MUUTOSMÄÄRÄYS **AIRWORTHINESS** **DIRECTIVE**

M 1367/86

1367. Beech. Siipirakenteiden tarkastus

Amendment 39-3878; AD 75-27-09 R2

FIGURE 1 AD 75-27-09

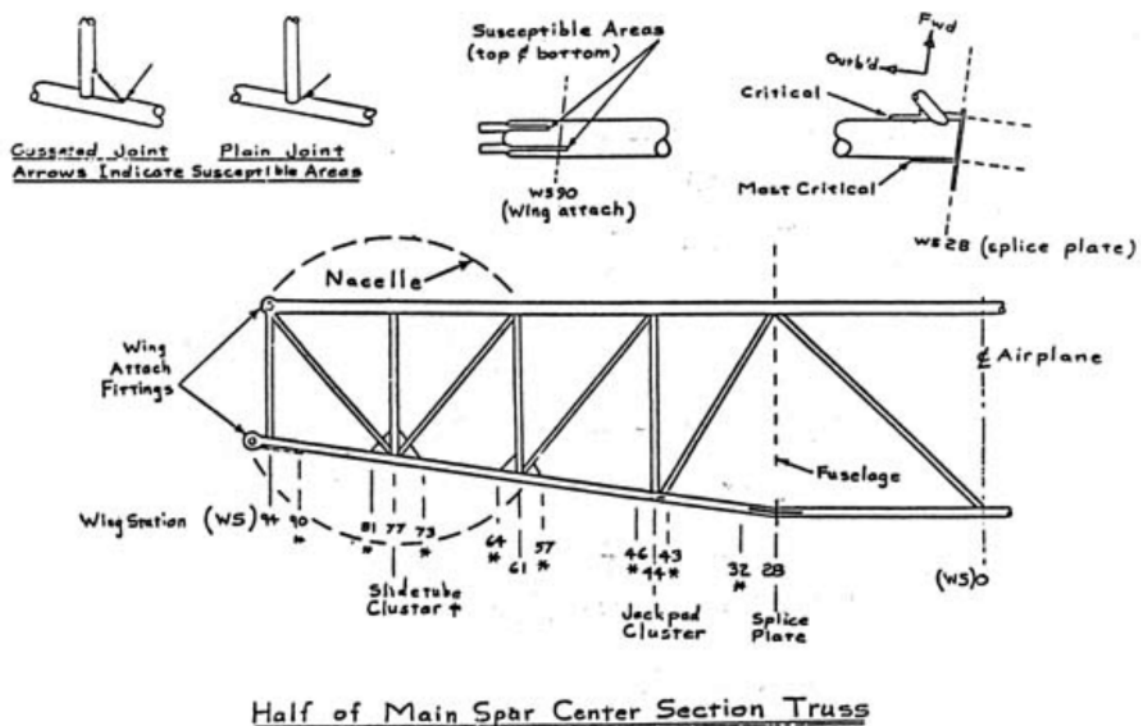
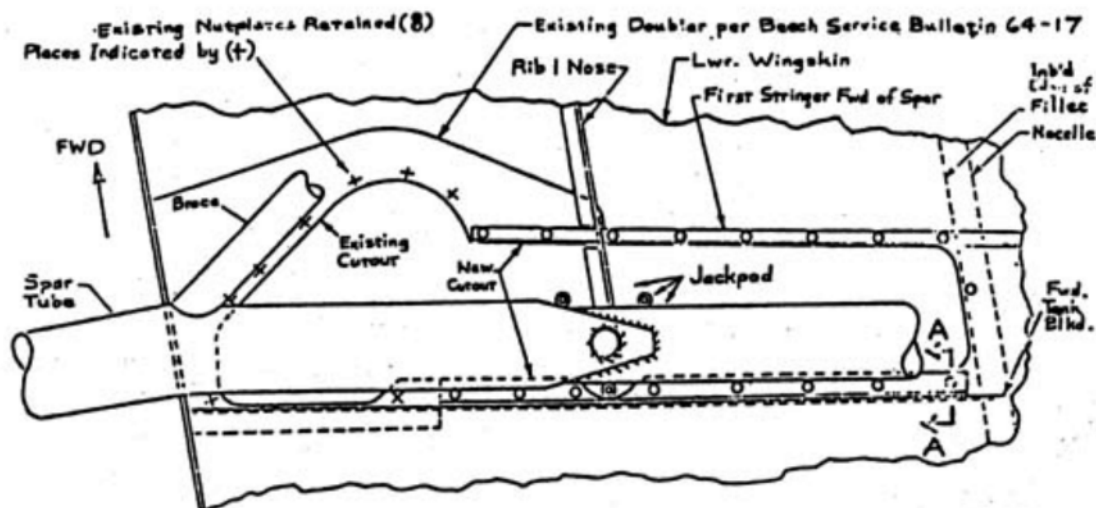
3. Inspect the front spar of the wing center section and outer wing panel at sites and by methods specified below.

* INDICATES AREAS TO BE INSPECTED PER THIS A.D.

FIGURE 2

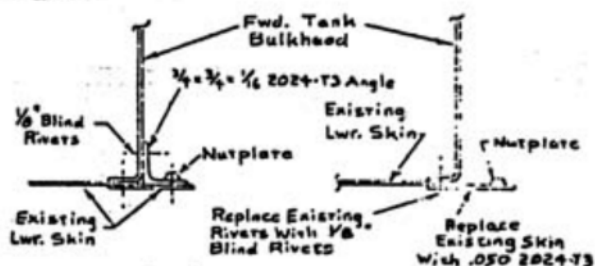
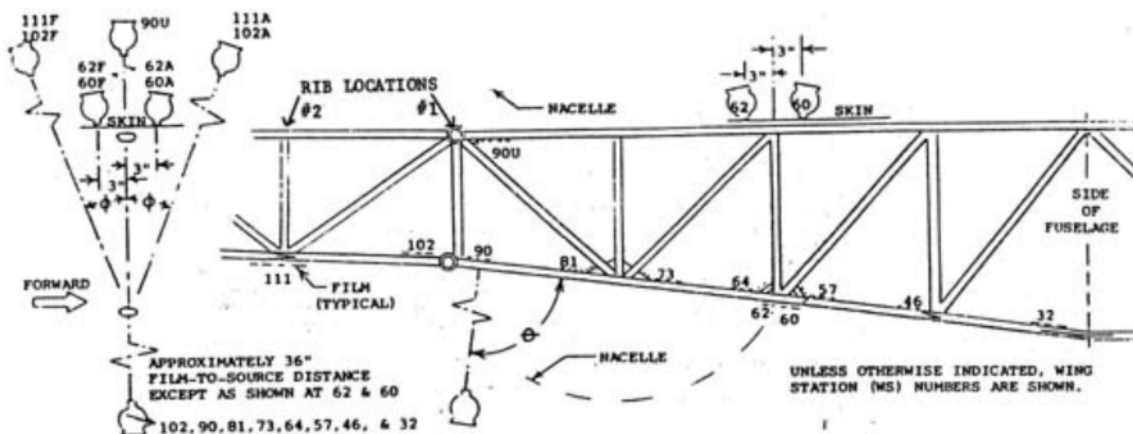
B) At the time of the next inspection of wing structure that is required by this directive, unless previously accomplished, incorporate inspection access provisions in accordance with Figure 2, below, or a Federal Aviation Administration (FAA)-approved equivalent. If additional access provisions are necessary for inspection of sites specified by reports per Subparagraph C)7., below, follow instructions from Beech Aircraft Corporation, and incorporate these provisions.

Attach MK1000-3 Nutplates (or equiv.) (17 places) as shown by (O). Cut inspection door from .032 2024-T3 Alum. Allow $\frac{1}{2}$ " edge margin around all screws (min). Install door on lower side with $\phi 10$ screws (25 places): cut three holes for jackpad access. Inspection door not shown.

FIGURE 4 AD 75-27-09

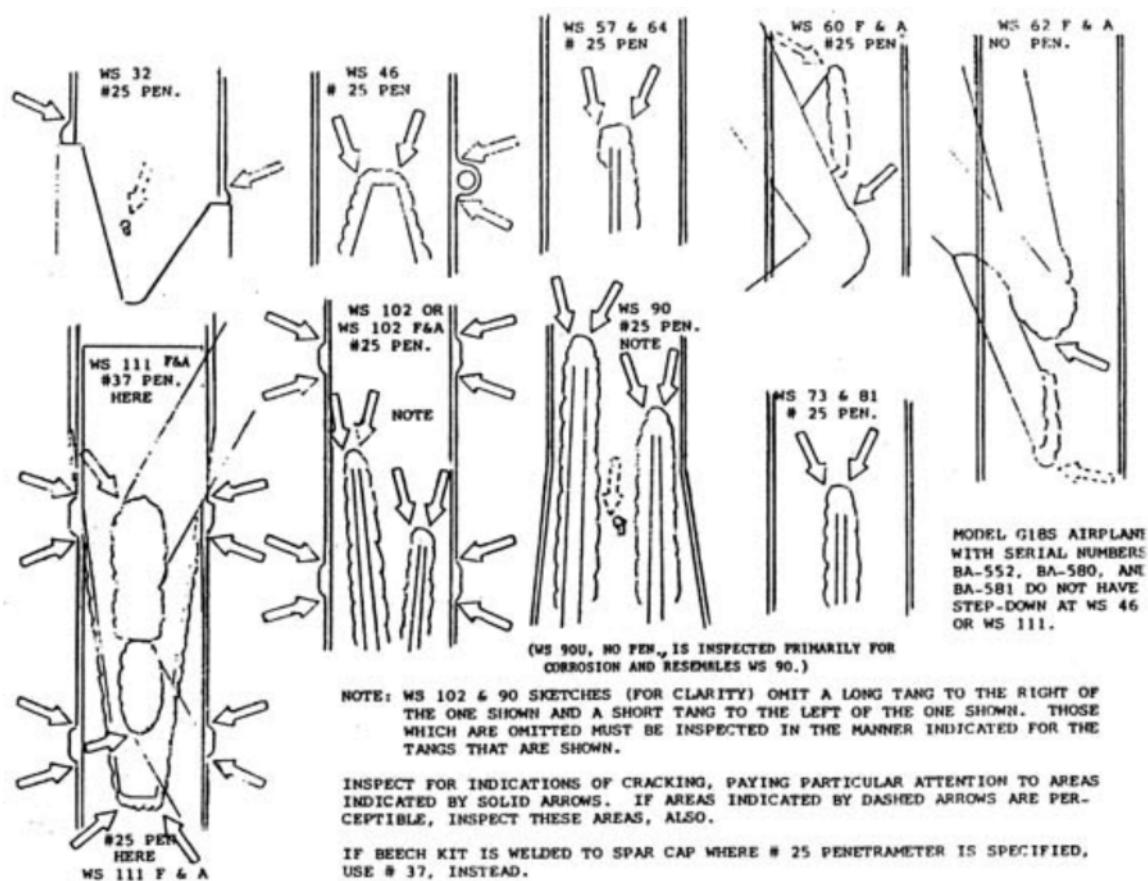
90	Tips of welds at clevis tangs, upper and lower surface	Visual, X-ray and either magnetic particle or penetrant
90U	Tips of welds at clevis tangs, upper and lower surface	X-ray
102 & 111	Tips of welds as shown in Figure 4	X-ray

e) Ascertain that neither the airplane nor the source will be moved by wind or other influences, and expose the film so as to obtain 1.5 to 2.8 radiographic density near inspection sites specified in Figure 4 of this directive. Use the same kinds of film and exposure time for WS 62 sites as for WS 60 sites.
